BOARD ACTION REPORT – APPEALABLE ITEM

Project Name: Bahia Delray
Project Location: 1001 Crystal Way
Request: Class IV Site Plan Modification consisting of the site plan, architectural elevations, and landscape plan.

Board: Site Plan Review and Appearance Board

---STAFF REPORT---

Client: BAHIA DELRAY
Address: 995 CRYSTAL WAY
Address: DELRAY BEACH, FLORIDA
Phone:
Plan: ELEVATION
8 UNIT BUILDING

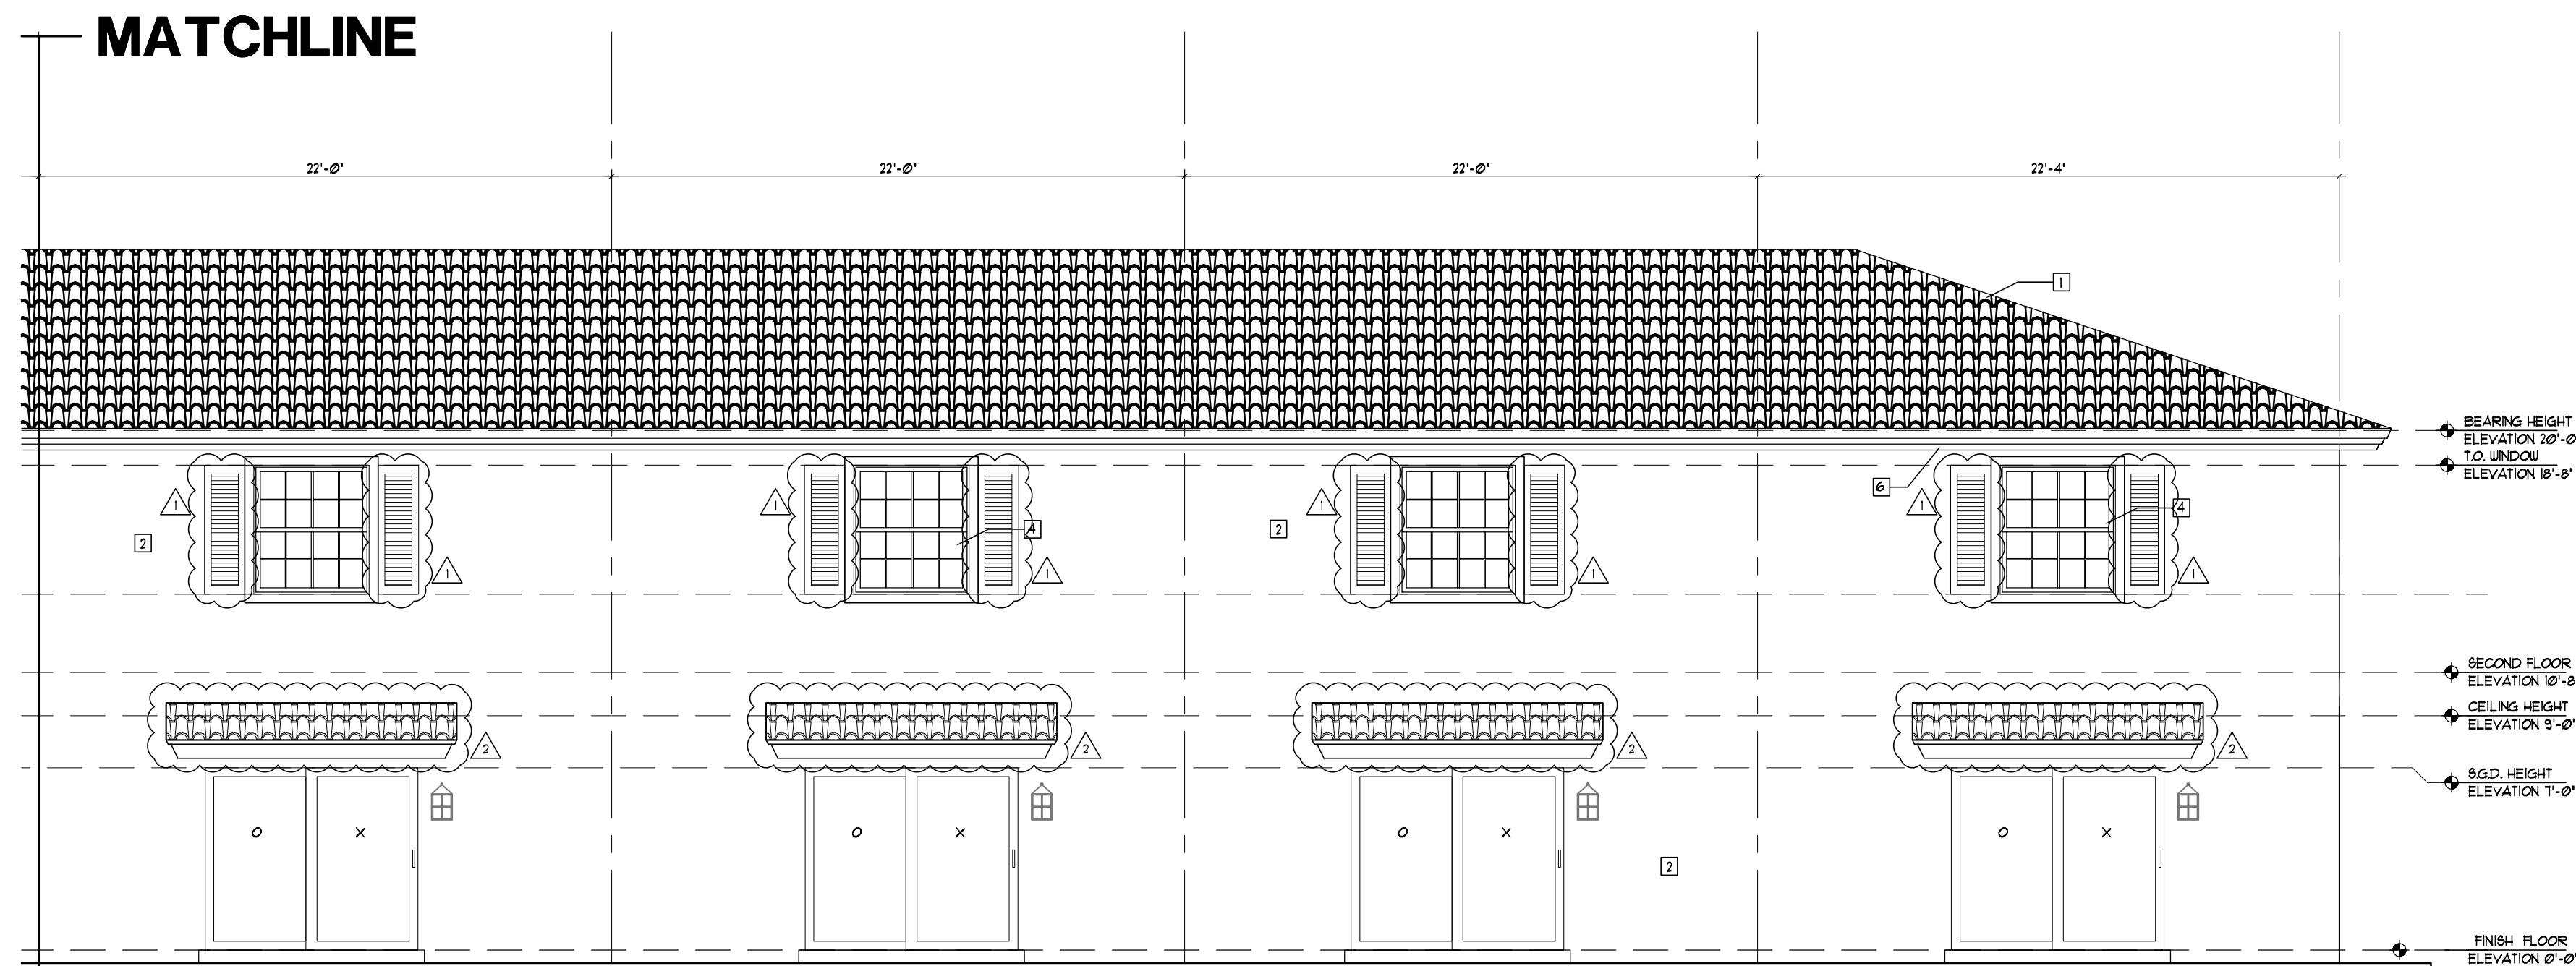
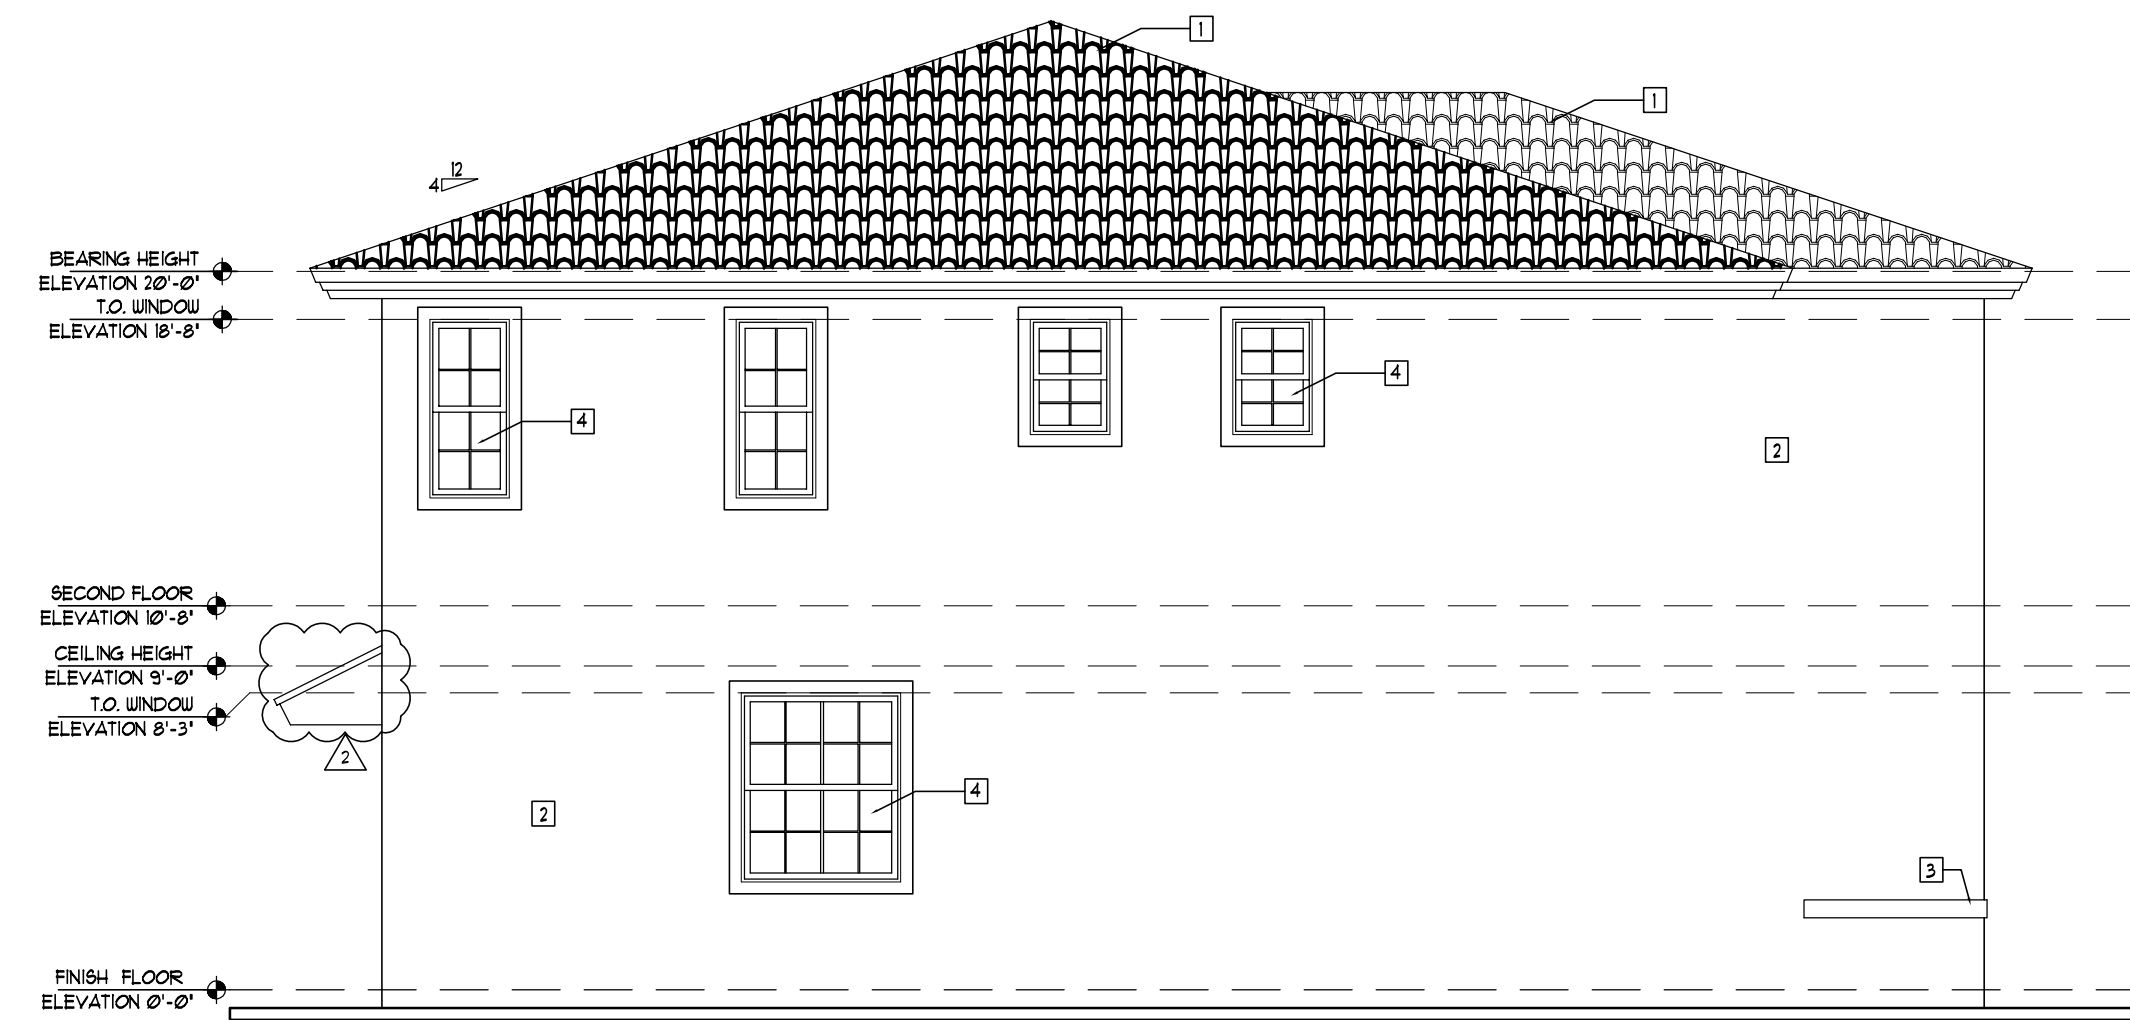
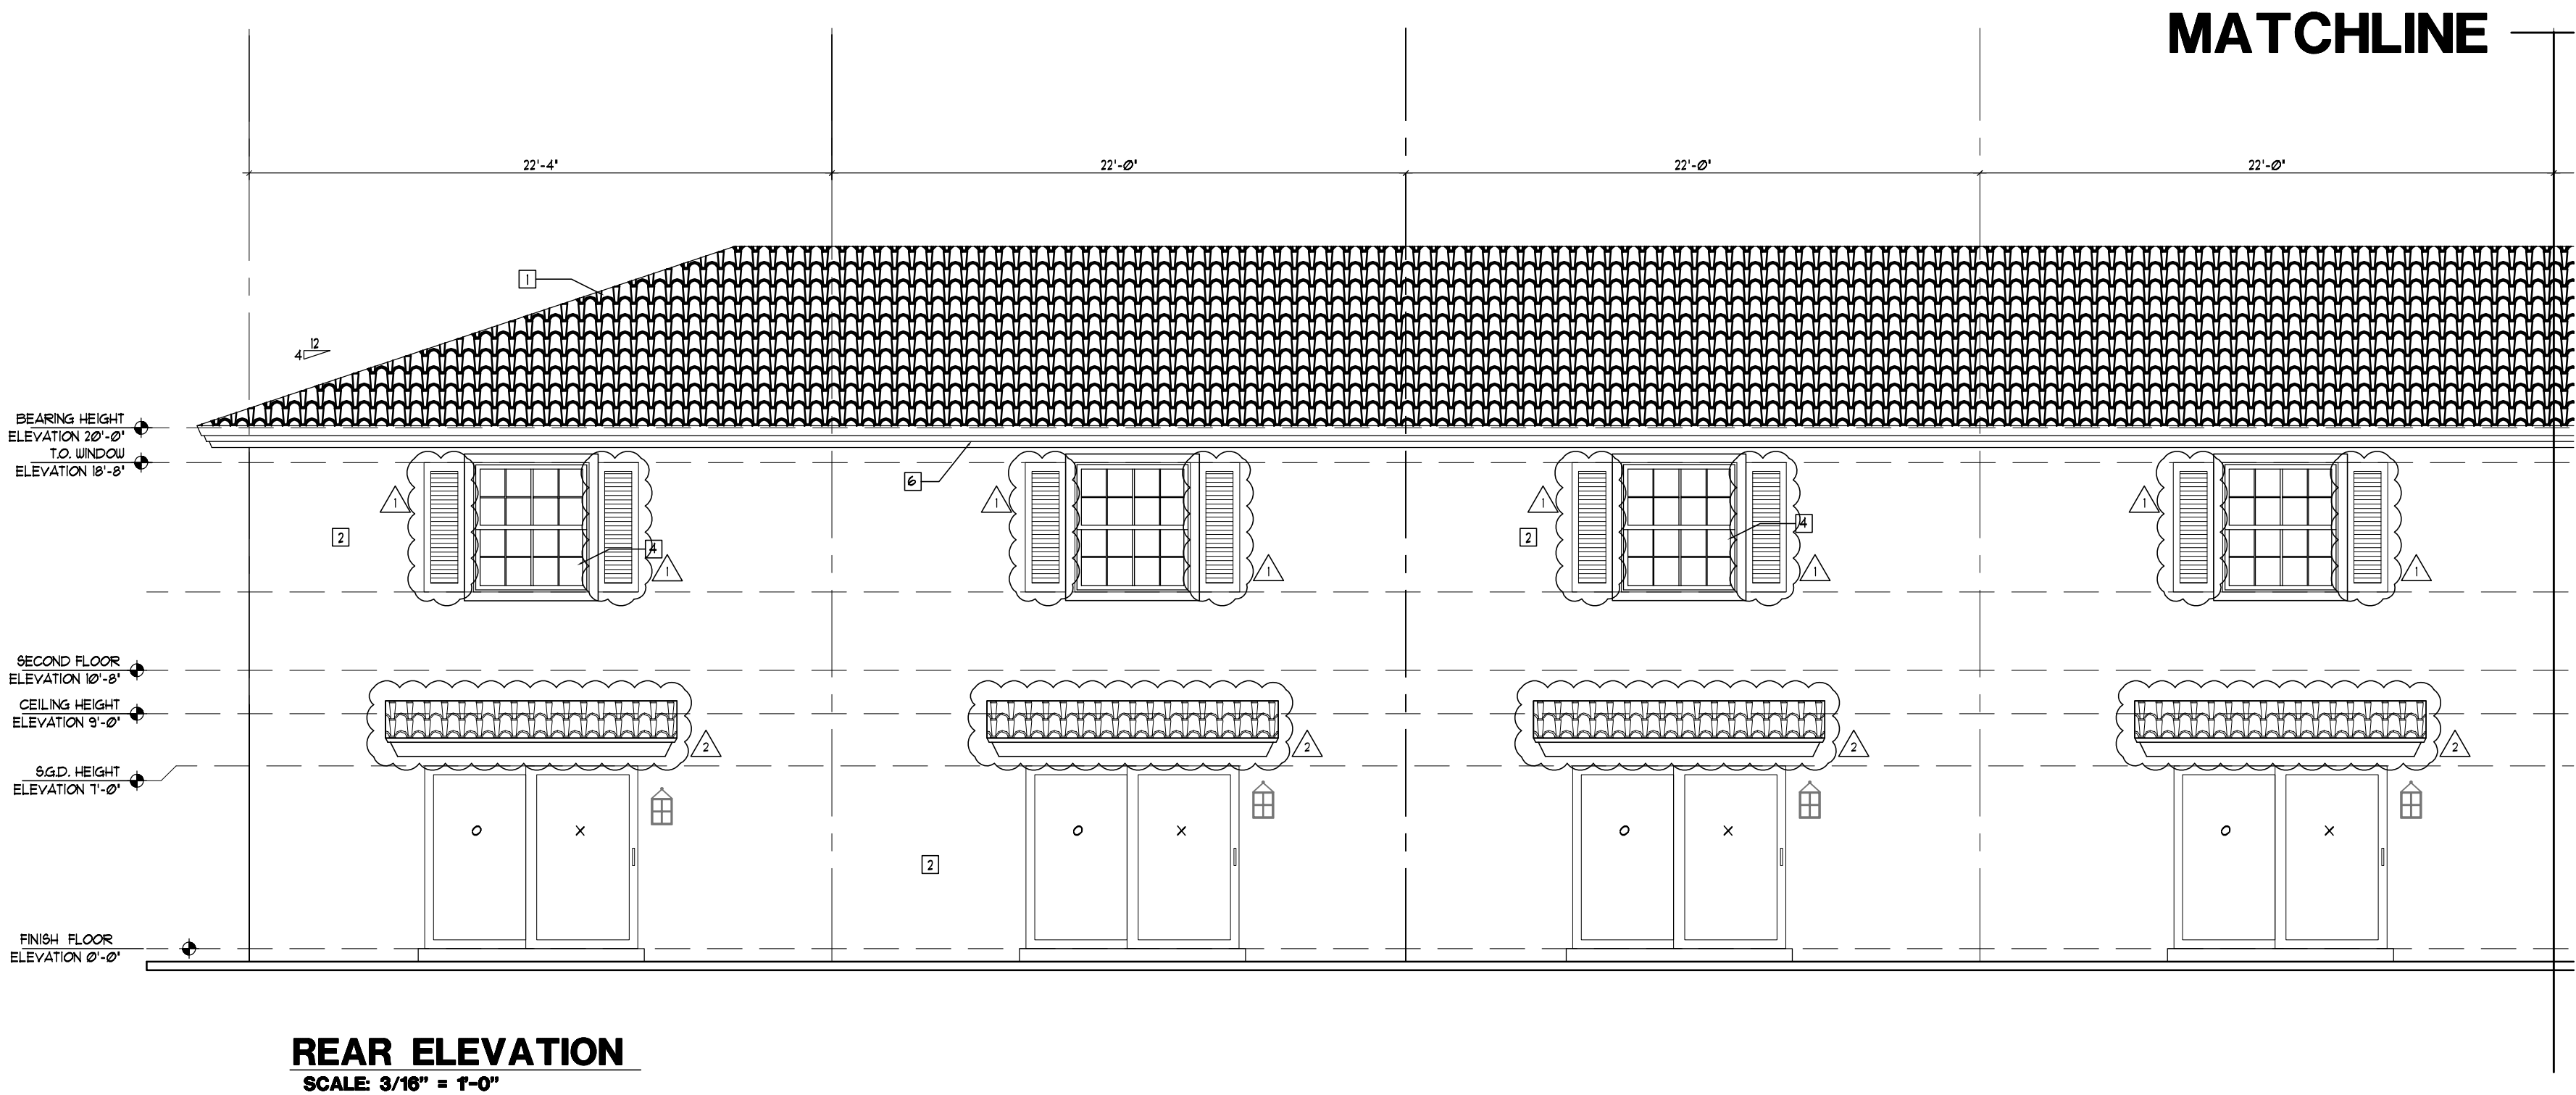
1. That revised elevations for Building #3 be provided which mirror the presently proposed elevations, to preserve Tree #197; and,
2. That the color scheme be revised to be consist with the existing development, including the roof tile color.

The proposed elevations consist of a lightly textured stucco with cementitious siding on the inset portion of the front elevation. The roof and entry overhangs at both the front and rear are finished with a beige "S" tile. The color scheme is a beige siding and puddy stucco with brown trim, accents, and shutters, light blue doors. The windows have white frames and muntins.

In general the proposal is in good taste and design, although it is simpler than the more decorative buildings that exist within the development. This differentiation may be determined to illustrate the different building and unit type, as also exemplified by the garage components within the new buildings. However, additional details and a revised color scheme, inclusive of the roof tile, should be provided to unify the new buildings with the existing buildings and/or the existing building painted to be consistent with the new buildings. The existing buildings are each painted differently in a pastel color, and are finished with a white flat, cement tile roof.

The proposed elevations can be supported with positive findings subject to the revision of the color scheme to appropriately compliment or match the existing buildings, including the roof tile color. This recommended revision will assist in providing harmony with the existing development while not causing depreciation to the development.
